STAFF RECOMMENDATION

1306 Lillian Street
September 19, 2012

Application: Demolition; Infill
District: Lockeland Springs-East End Neighborhood Conservation Zoning Overlay
Council District: 06
Map and Parcel Number: 08313014700
Applicant: Jaime Pfeffer
Project Lead: Michelle.Taylor3@nashville.gov

1 SITE PLAN
 SCALE 1/32" = 1'-0"

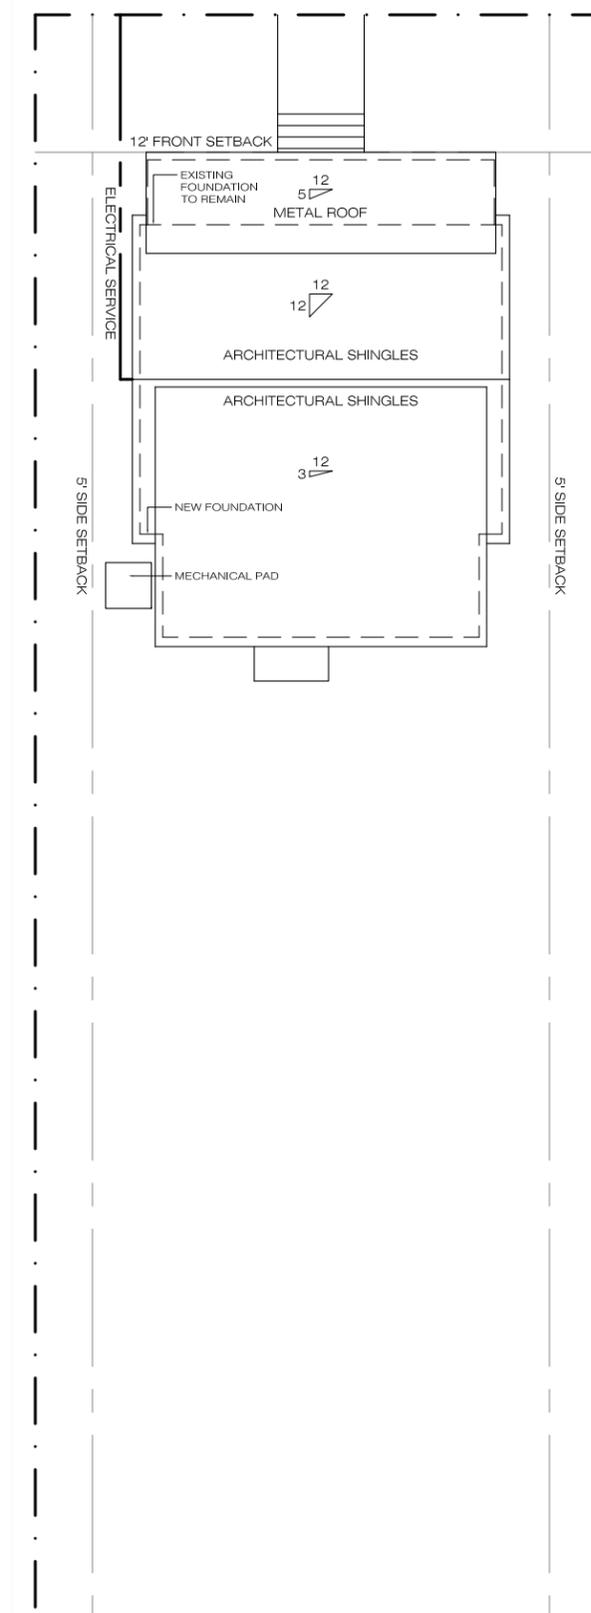
The structure will be located with the leading edge seven feet (7') from the front property line matching the front setback of the existing house and the house to the left (1308 Lillian Street). The left and right side will both be eight feet (8') from the property line. These setbacks are compatible with the rhythm established by other houses on the street, meet bulk zoning requirements, and meet guideline II.B.3. The structure will be oriented square and perpendicular to the street, consistent with historic houses in the surrounding area and meeting guideline II.B.6.

1 FRONT ELEVATION
SCALE 1/8" = 1'-0"

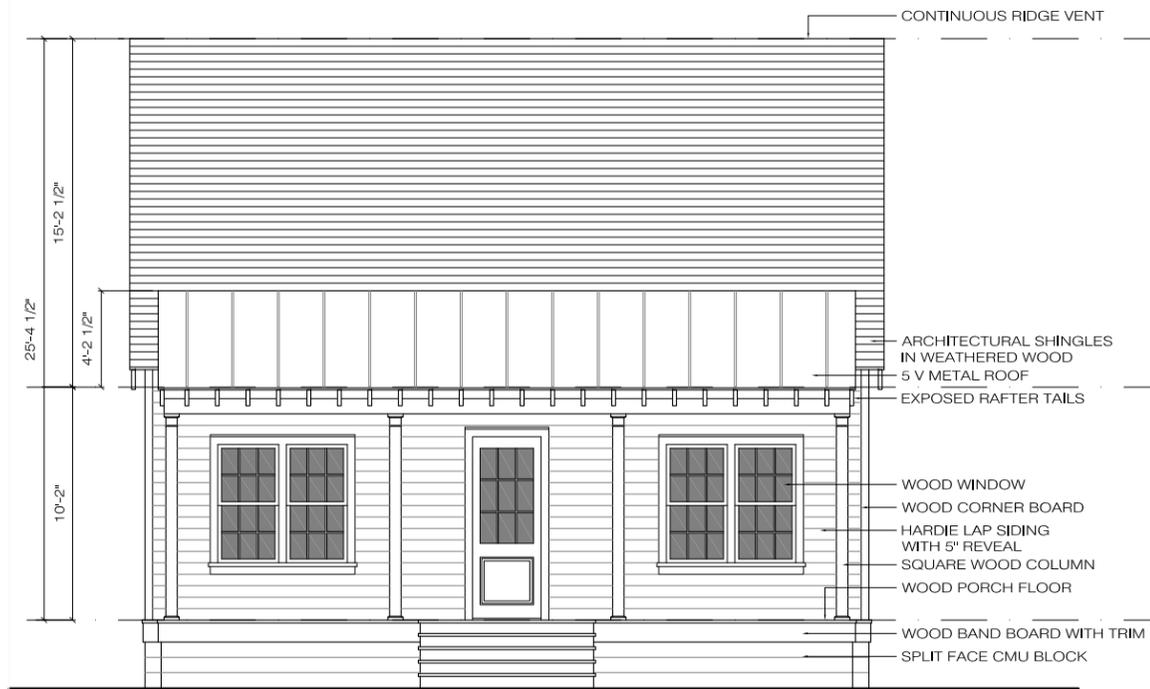
The front elevation of the structure will have a central doorway, flanked by a bay of two-part windows on each side. The window patterns on the right and left elevations match the historic context. Staff finds the proportion and rhythm of windows to be compatible with surrounding historic houses and to meet guideline II.B.7.

Staff recommends approval of the demolition of the non-contributing structure and the proposed new infill with the conditions that staff review final details for windows, doors and roof color. With these conditions, the application meets the applicable design guidelines for the Lockeland Springs-East End Neighborhood Conservation Zoning Overlay.
